**PROPOSED 'PLACE OF RECREATION, SPORTS OR CULTURE
(PUBLIC RIDING SCHOOL WITH ANCILLARY FACILITIES)' AT
THE RESTORED LANDFILL SITE (TKOL II/III)
IN TKO AREA 105, TSEUNG KWAN O (GLA TSK-500)
(TPB No. A/TKO/134)**

RESPONSES-TO-COMMENTS TABLE

PROPOSED PLACE OF RECREATION, SPORTS OR CULTURE (PUBLIC RIDING SCHOOL) WITH ANCILLARY FACILITIES AT GOVERNMENT LAND IN D.D. 233, THE RESTORED LANDFILL SITE (TKOL II/III) IN TKO AREA 105, TSEUNG KWAN O (GLA TSK-500 (PART)) [TPB REF: A/TKO/134]

REVISED SWEEP PATH

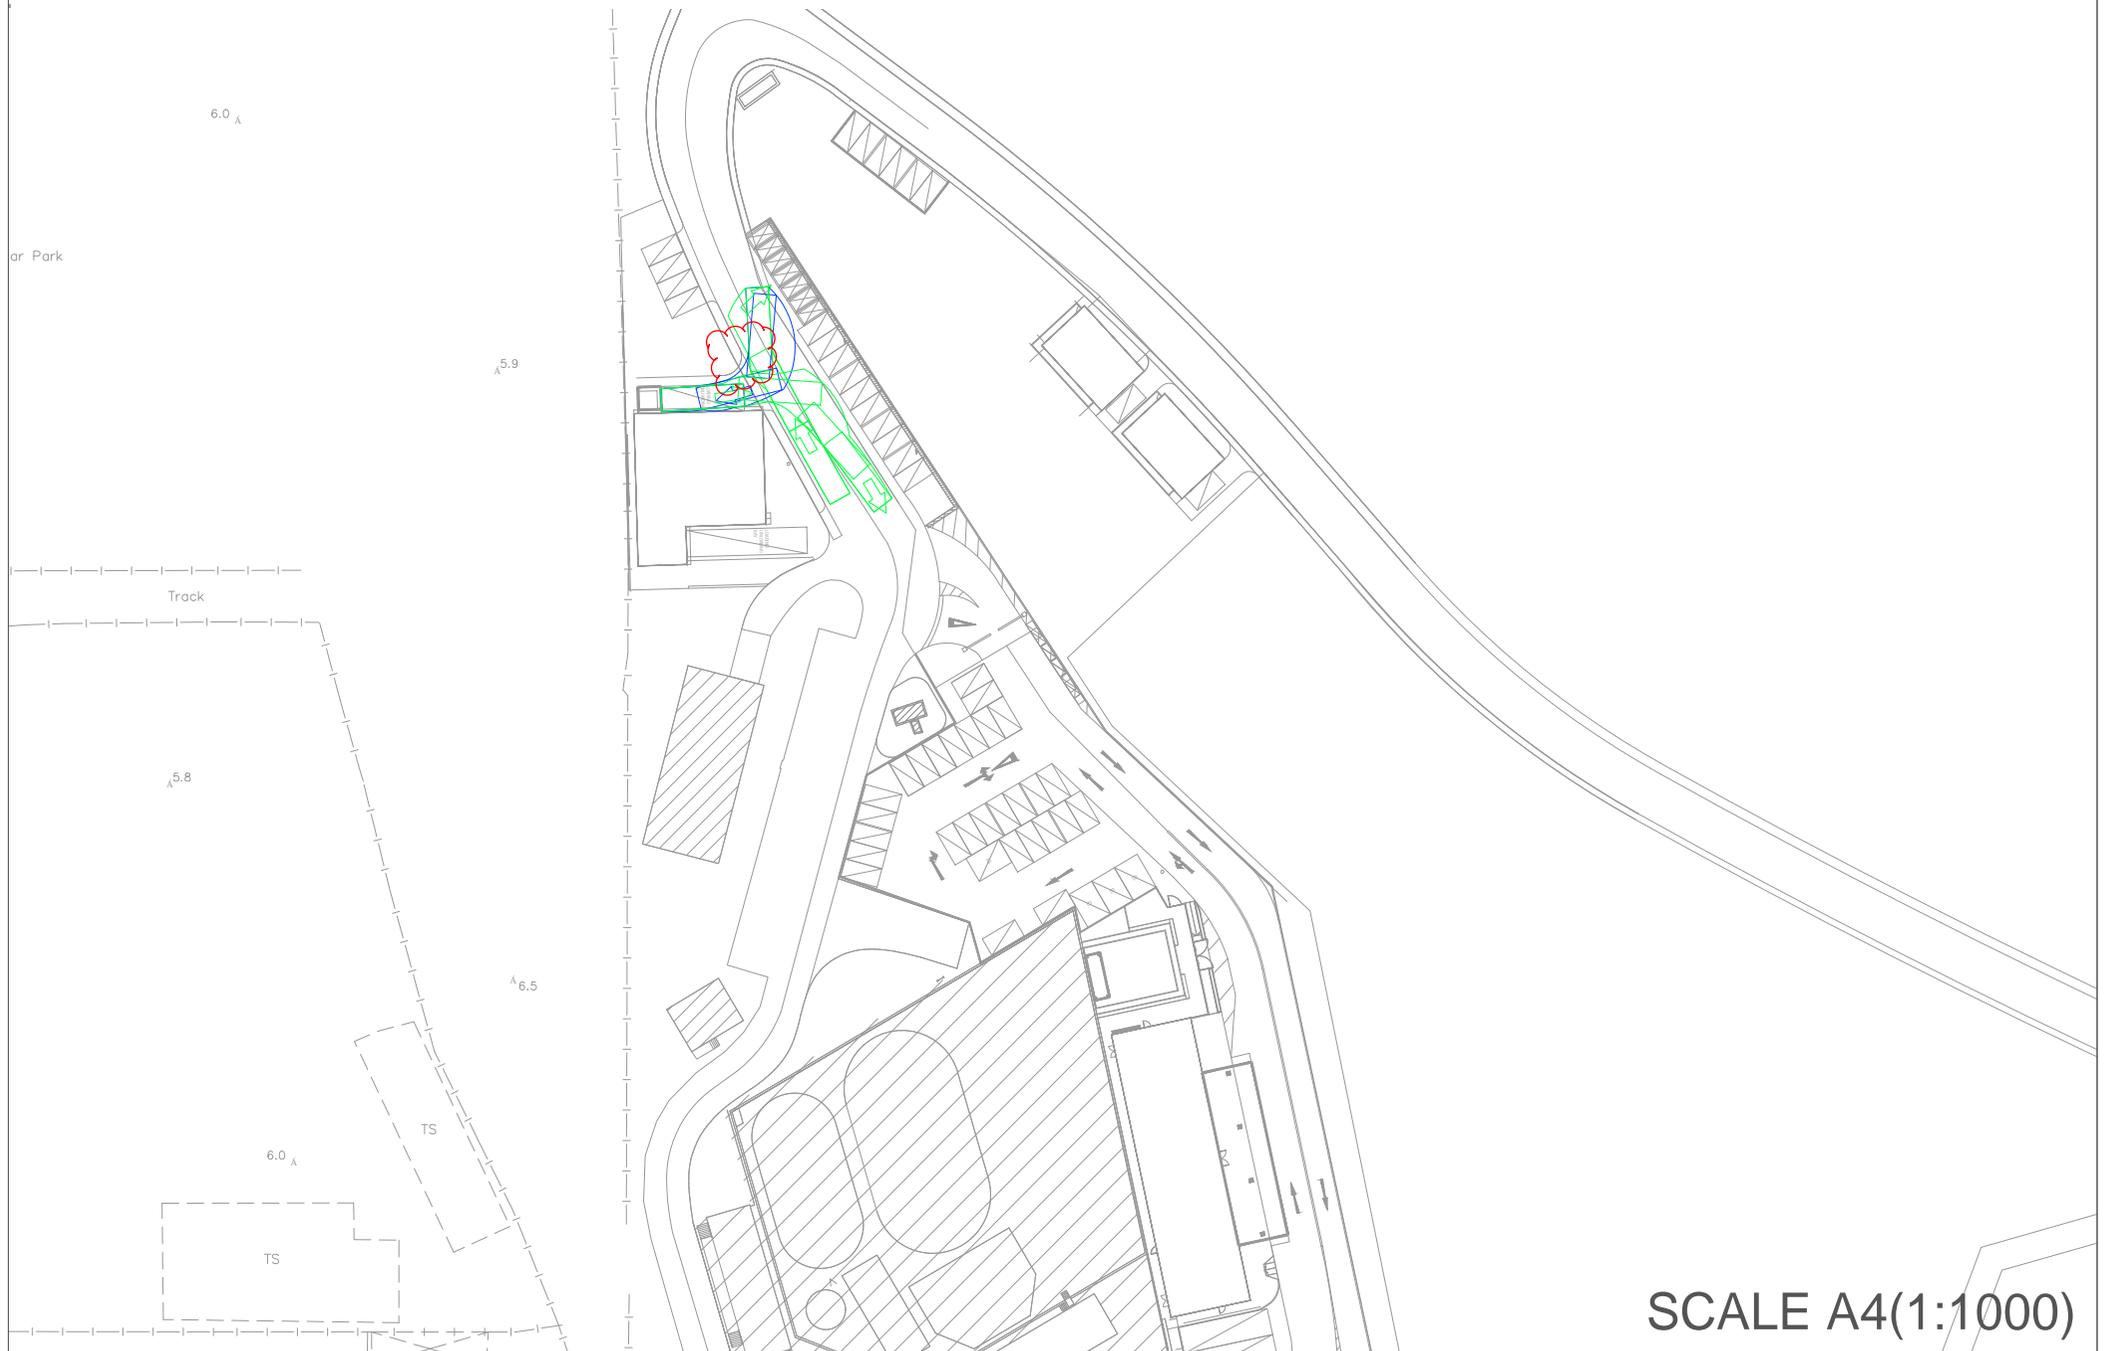
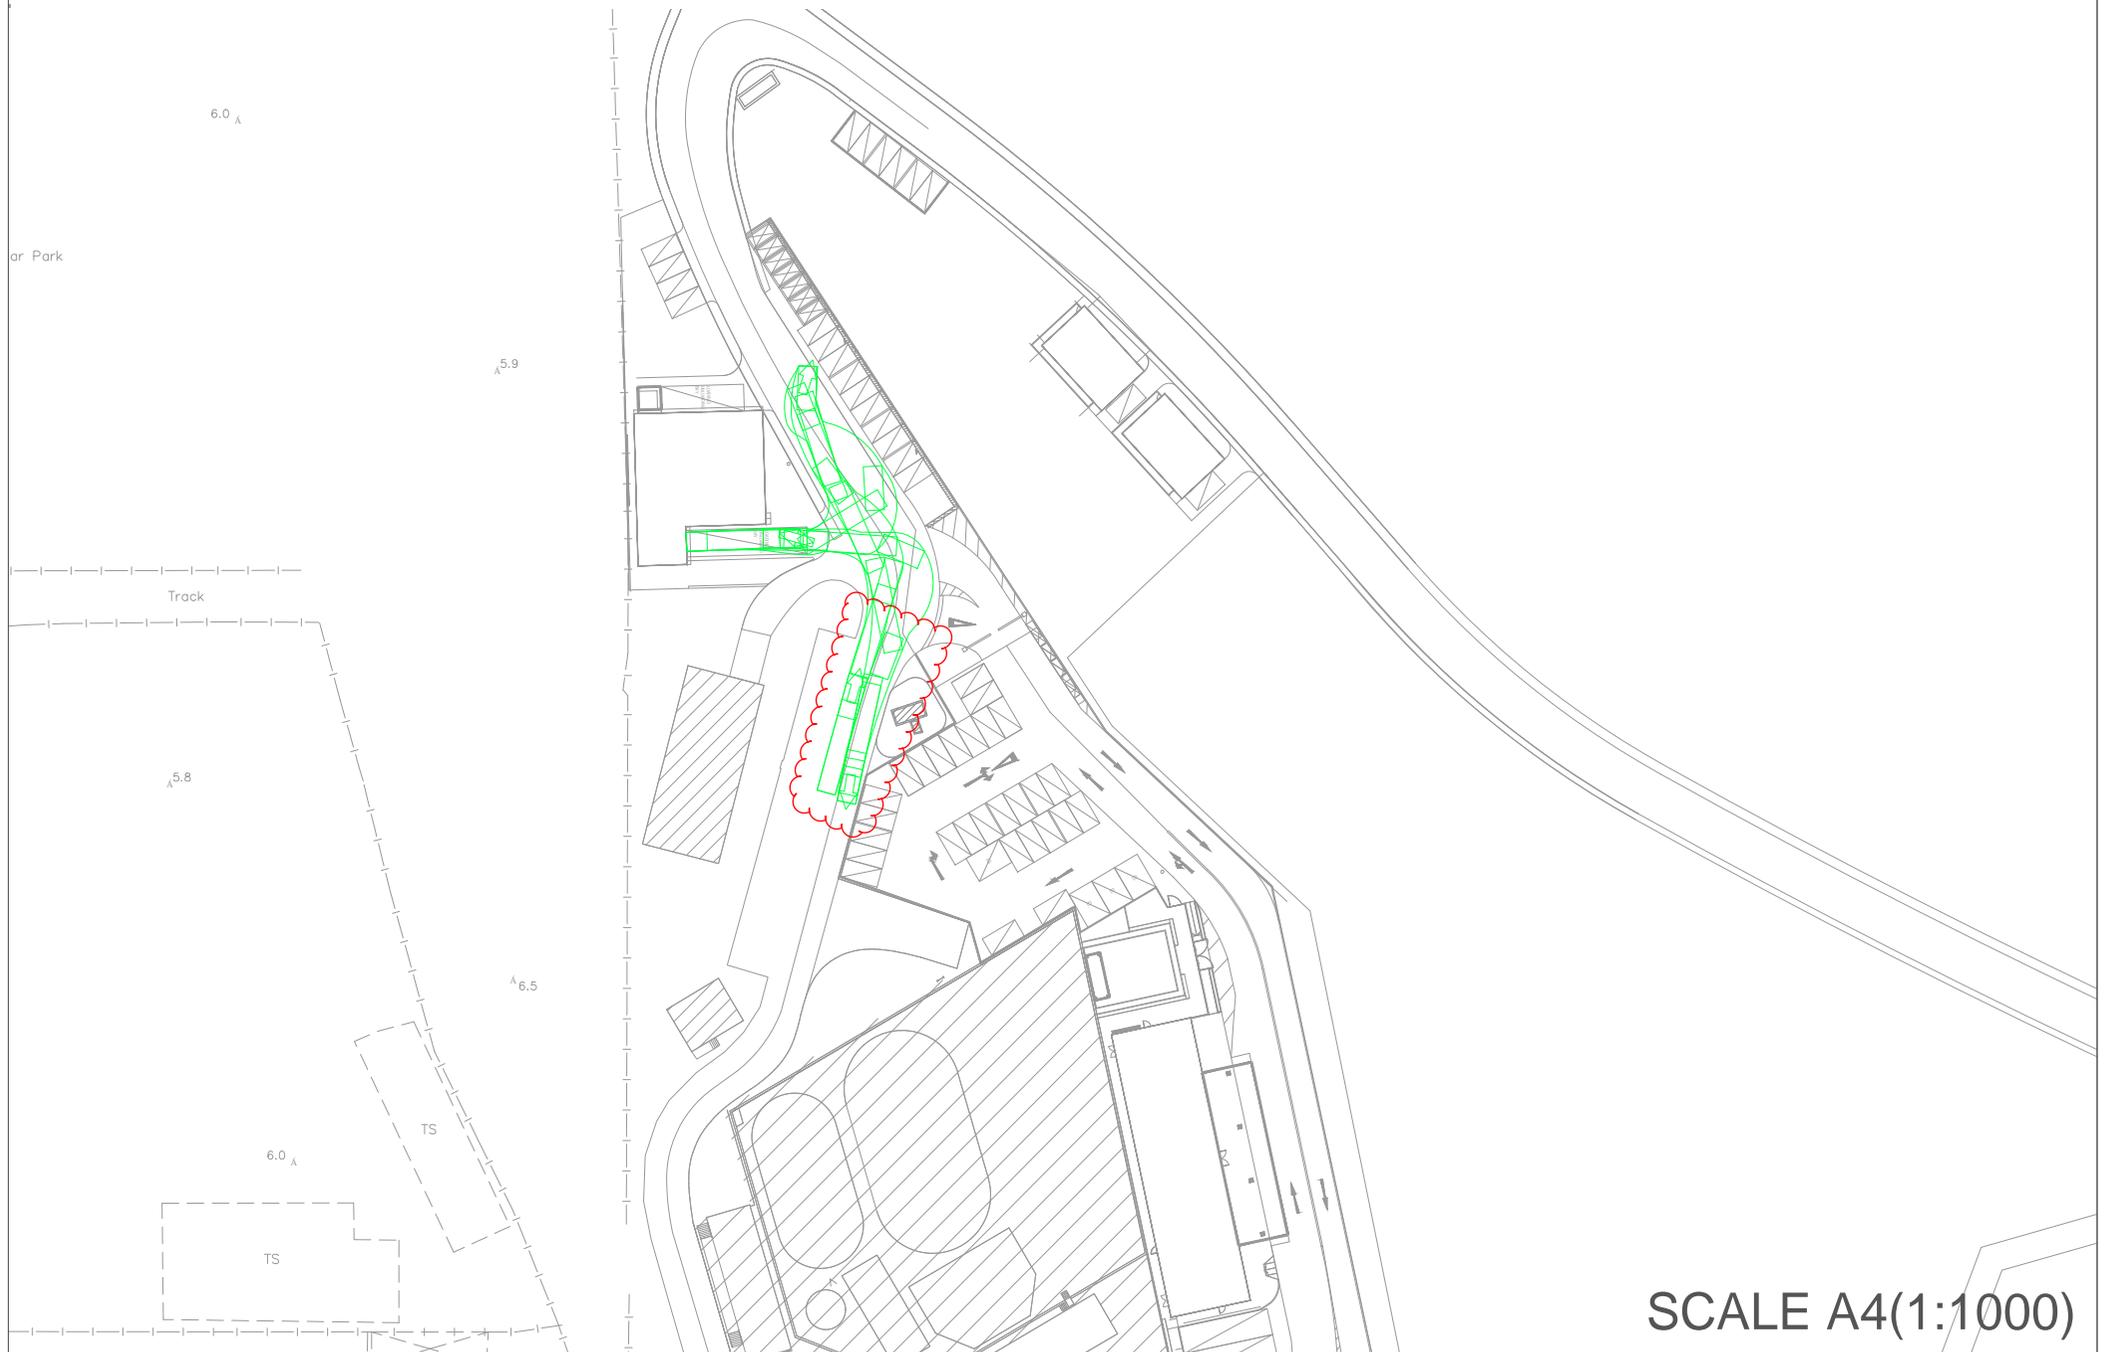
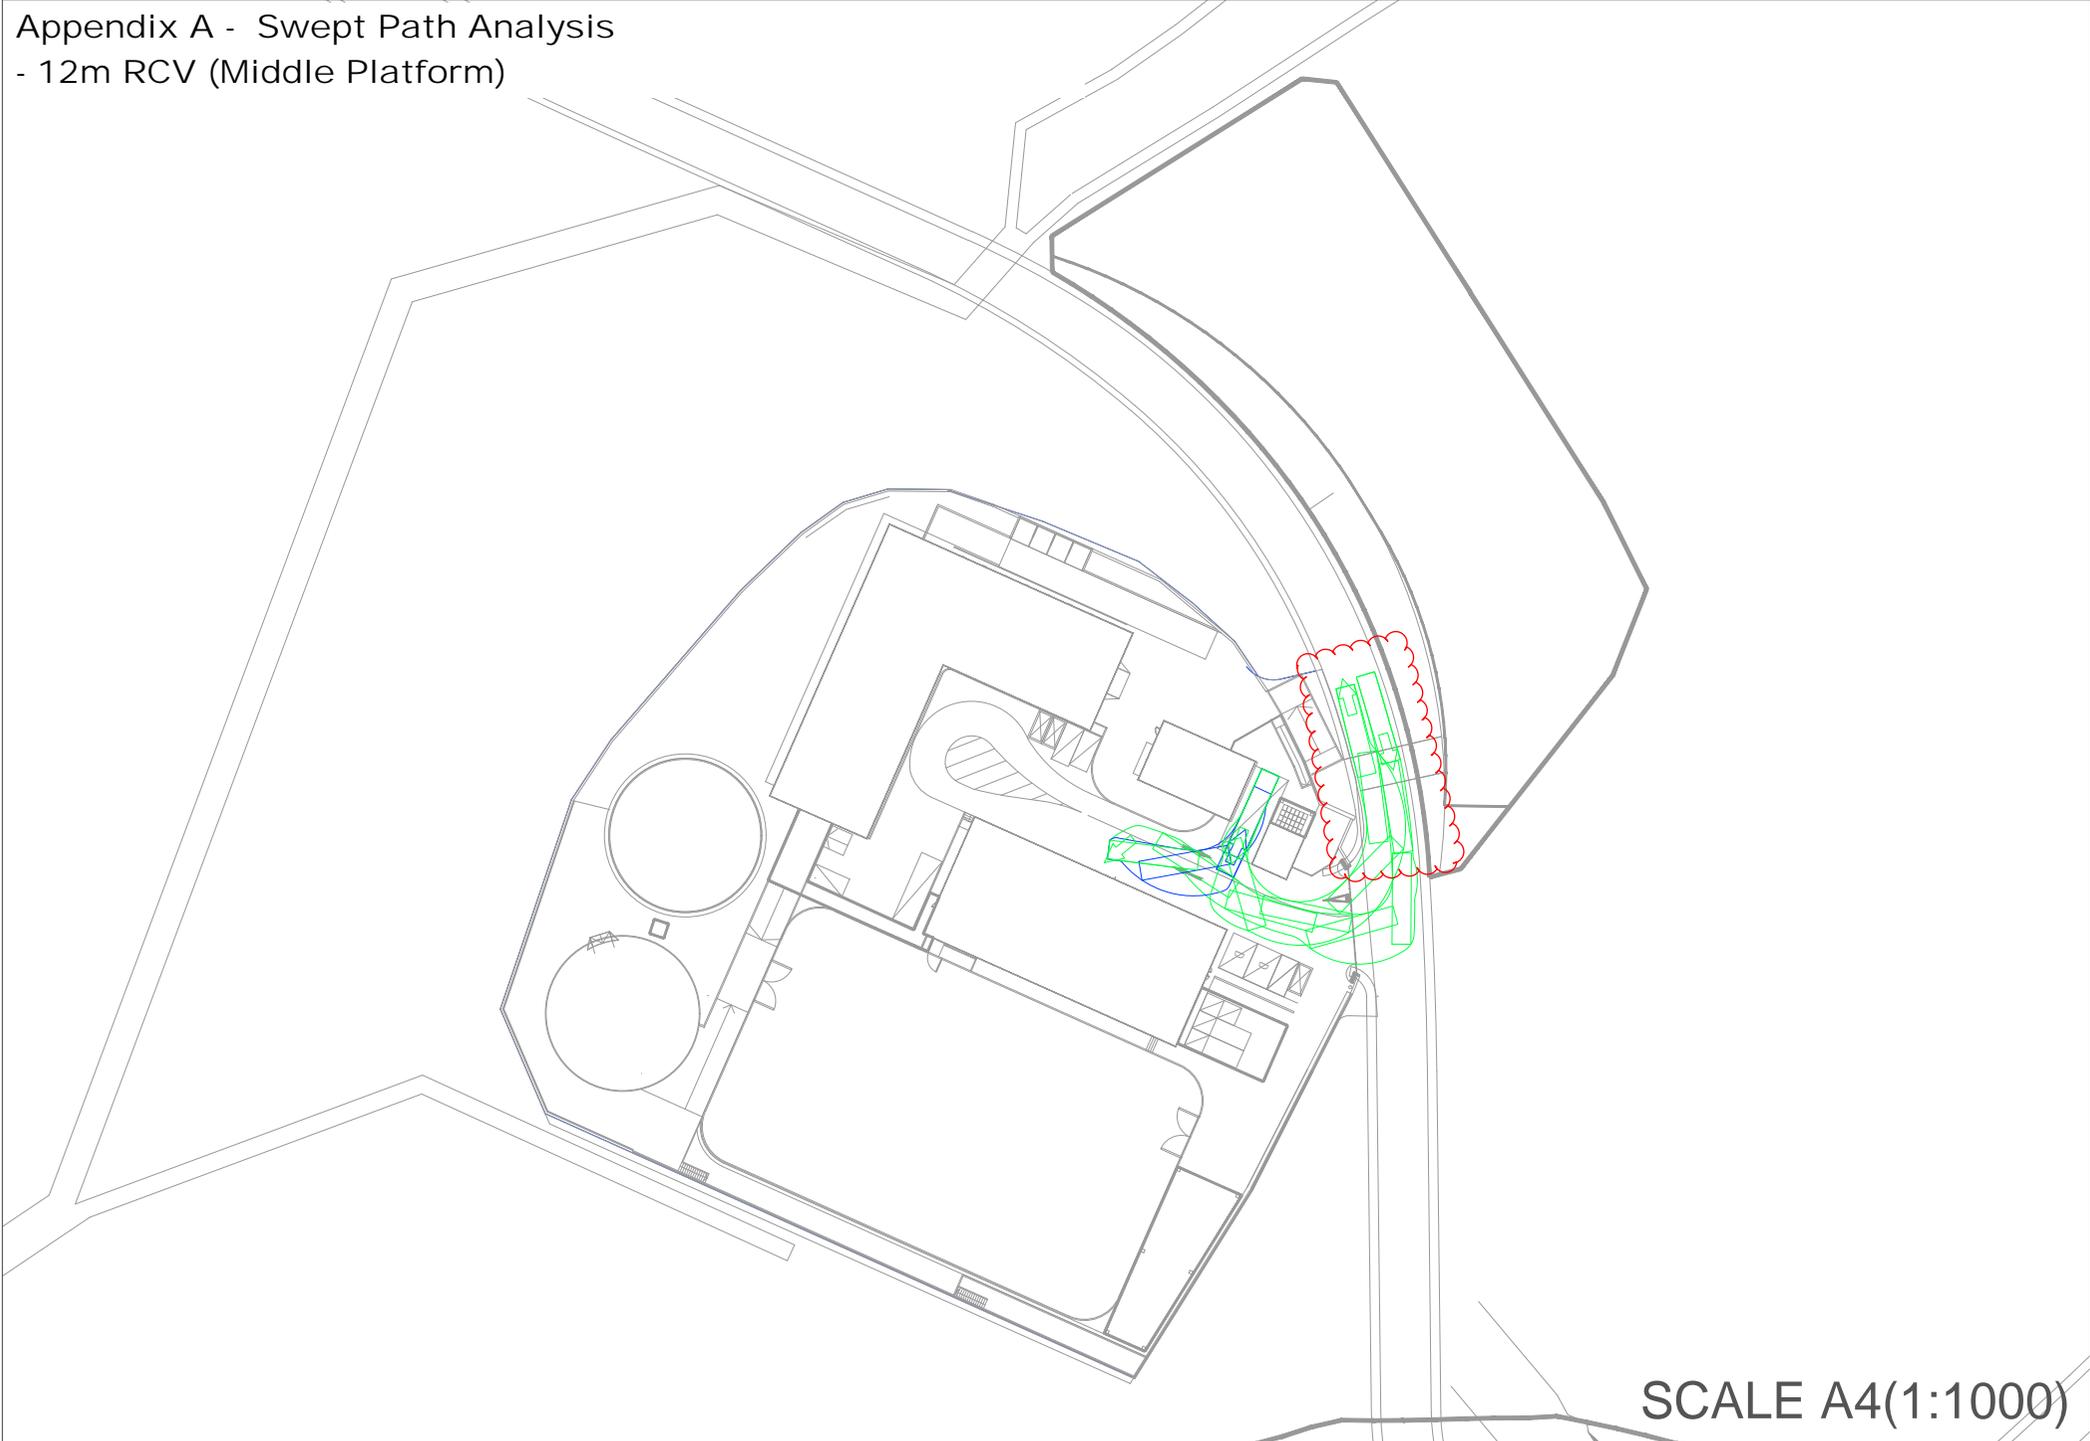
Comments/ Suggestions	Applicant's Responses
A. <u>Comments received from Transport Department on 9.3.2026 (Contact Person: Mr. Kelvin KWONG; Tel.: 2399 2402):</u>	
<p>1. We have the following comments on the Traffic Impact Assessment at Appendix 3 of the submission:</p> <p><u>Comments from Traffic Engineering (NTE) Division</u></p> <p>a. Section 1.1.1 – Please correct the first sentence “This XXX (Assessment) is prepared...” as appropriate.</p> <p>b. Table 2.2 – Please correct the typo of “Total 59 nos.” in Note (1).</p> <p>c. Table 2.2 – With reference to Table 4.2 of the Supplementary Planning Statement Note *(2), there would be 28 + 4 nos. of car parking spaces for visitors and 22 nos. of the car parking spaces for staff. Please clarify how the number was derived.</p> <p>d. Table 2.2 Remark – The project proponent should conduct public consultation for the proposed cycle parking facilities.</p> <p>e. RtoC Attachment A – Please review the swept paths as marked in <u>Appendix I</u>. Our previous comment to indicate the critical widths remains valid.</p> 	<p>Noted and Section 1.1.1 of the Traffic Impact Assessment (“TIA”) has been revised. Please refer to the replacement pages of the TIA (<i>Attachment 2</i> refers).</p> <p>Noted and Table 2.2 of the TIA has been revised. Please refer to the replacement pages of the TIA (<i>Attachment 2</i> refers).</p> <p>Please be advised that the total parking provisions have made reference to Tuen Mun Public Riding School, while the allocation of staff parking and visitor parking are based on the operational needs of the Proposed PRS.</p> <p>Noted and the remark in Table 2.2 of the TIA and Table 4.2 of the SPS have been updated. Please refer to the replacement pages of the TIA and the SPS (<i>Attachments 2 and 3</i> refer).</p> <p>Noted and please refer to <i>Attachment 4</i> of the RtoC Table for the revised swept path.</p>

Comments/ Suggestions	Applicant's Responses
<div data-bbox="250 308 757 651"> <p>Appendix A - Swept Path Analysis - 16m Articulated Vehicles (Lower Platform)</p>  </div> <div data-bbox="250 675 757 1023"> <p>Appendix A - Swept Path Analysis - 12.5m RCV (Middle Platform)</p>  </div> <p>f. Section 2.5 – Please note that the concerned access road with proposed cautionary pedestrian crossing is not managed by TD. Please seek comment from relevant parties. In general, TD does not assume the management responsibility for access roads of such nature, which are not intended for general commuting purpose. Also, consultation with affected parties/ stakeholders may be needed. Please seek separate comment from HyD from the maintenance viewpoint.</p> <p>g. Drawing 3.9 and Table 3.7 – Please clarify if F6 for assessment should be northern footpath of Chun Yat Street near Wan Po Road SB, with reference to the walking route in Annex A. Please update Section 7 as appropriate.</p>	<p>Noted. Please note that Highways Department (New Territories East District and Maintenance Division of New Territories Region) was consulted and advised no comments on the proposed works.</p> <p>Typo and please be clarified that F6 should be the northern footpath of Chun Yat Street. Please refer to the replacement pages of the TIA (Attachment 2 refers).</p>
